**ITEM 9. DEVELOPMENT APPLICATION: 331-333 GEORGE STREET SYDNEY****FILE NO: D/2012/696****DEVELOPMENT APPLICATION NO: D/2012/696****SUMMARY****Date of Submission:** 14 May 2012, amended drawings received 11 October 2012 and 16 November 2012.**Applicant:** Charter Hall Funds Management Pty Ltd.**Architect:** Grimshaw**Land Owner:** The Trust Company Limited.

Figure 9: Detail of column in front of glazing

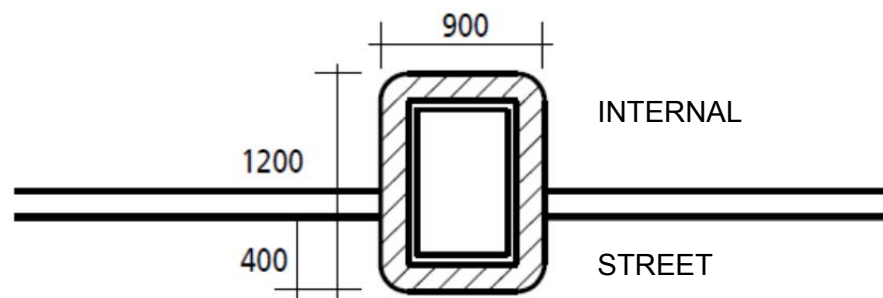
17. Whilst all the proposed Facade Types shown above propose masonry features, the masonry sandstone elements on Facade Type 3 being partially external to the glass line are more substantial especially when viewed from George Street (as shown above).
18. Facade Type 3 proposes exposed columns with retail glazing to the ground plane, level 1 and level 2 with the glazing extending partially over level 2 to improve the environmental performance of the office space on level 2.
19. Facade type 3 is the preferred design scheme of the applicant and Council.

Figure 12 – North boundary design resolution concept

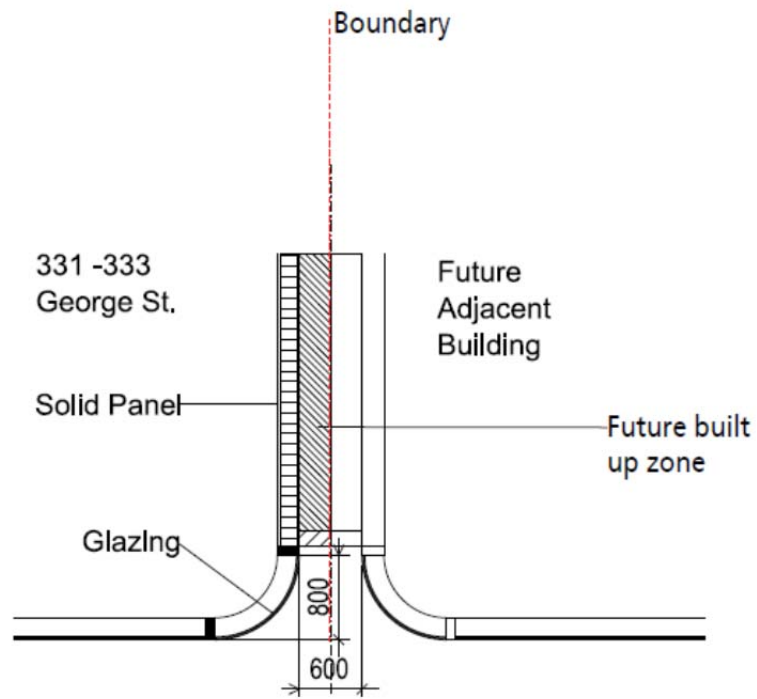
21. Both elevation options are considered acceptable and propose the introduction of solid infill panels within the 1800 facade grid and both options provide a transition from the glazed element through to the solid core.
22. The proposed concepts provide an articulated facade and respond to the concerns raised by Council officers and the Design Advisory Panel.
23. Facade Type 3 (Figure 8 above) and northern elevation Option 2 (Figure 11) are the preferred design concepts and the assessment of the development application will be finalised based on these drawings. Refer to issues section.
24. The concept plan details the design resolution of the façade to the north boundary in the event that the northern neighbouring building will be developed. This includes a tightened radius of the curved building element similar on all levels and the shadow gap.

**Figure 14: Roof top terrace plan - The edge of the shaded area shows the location of the balustrade when set behind the solar access plane restrictive area (compliant scheme).**

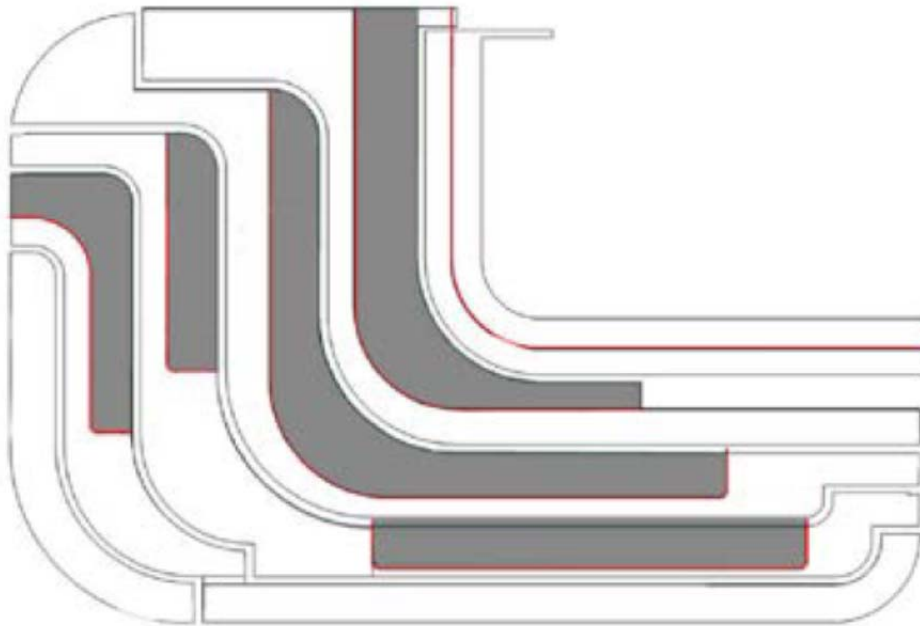
44. The draft height control is Area 3 – Sun Access Plane. The proposed building is contained wholly within the sun access plane except for a portion of the glazed balustrade located on the roof top terrace. A condition is recommended requiring the balustrades to be setback so as not to protrude into the Sun Access Plane restrictive area.

70. The applicant has requested that the balustrades be permitted in their current configuration as the impact of setting them back will result in the loss of 148sqm of rooftop terrace floor area (i.e. 42% reduction) with the majority of the remaining space being of a dimension that is not useable.

71. As detailed above, any additional overshadowing results in a prohibition. The applicant's justification has been considered. Accordingly a condition is recommended requiring the balustrade be relocated out of the 'no additional overshadowing zone'.

- (3) The roof top terrace balustrade is to be setback to be wholly within the Sun Access Plane height restriction unless the Director City Planning, Development and Transport provides written advice that the transparency of the glass balustrades are acceptable.
